## APPENDIX 2 – CHANGES TO THE DISTRICT PLAN

### Amendment 1

#### Amend Masterton Edition Volume 2 Maps of the District Plan as follows:

Insert new Appendix 16:

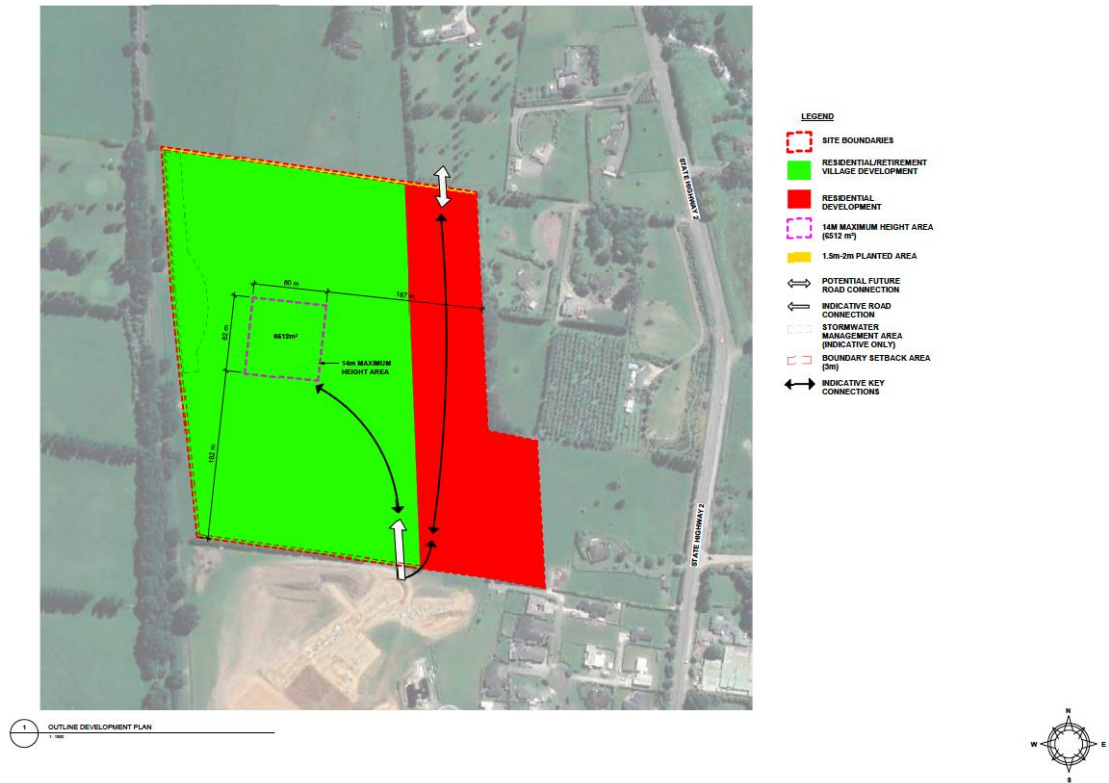
~~Modified by: extending the 1.5m-2m planted buffer around all external site boundaries.~~
